Access Compliance Report Public Rights-of-Way (Pedestrian Signals)

Main Street: BOLSA_AVE Cross Street: PURDY_ST Location: E

ADA ID: SGRK211005132802 Signal Type: One Push Button-Non APS Overall Compliance: No Severity Scores: BTN 1: 60 BTN 2: N/A No BTN: N/A

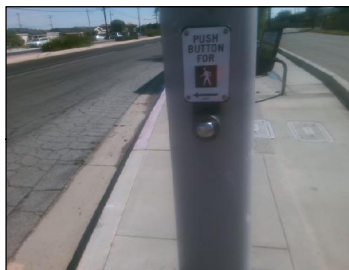
OC Std/PROW: R404.1, R404.2, R404.7.1, R404.7.3, MUTCD 4e.08

Possible Solutions: Replace Signal Push Button With APS Button. Remove and Replace Clear Space.
